Access Compliance Report

Public Rights-of-Way

(Pedestrian Signals)

Intersection ID: N/A	Main Street:	Cross Street: N/A	Location: N/A
ADA ID: 64C1266A73AB	Signal Type: One Push Button-Non APS	Overall Compliance: No	Severity Score: BTN 1: N/A BTN 2: N/A No BTN: N/A
Codes/Mitigation Info/Possible Solution		Field Measurements/Component Compliance

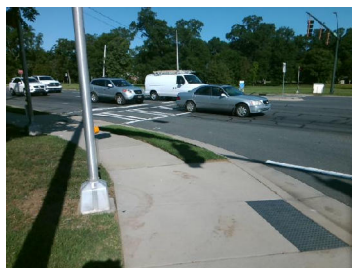
Surveyor Notes: TEXT HT 1/2

PROW/ADA: R410.6, TMUTCD 4e.08, R404.2, R404.3, R406.2

Possible Solutions: Replace Signal Push Button With APS Button on New Post. Remove & Replace Sign.
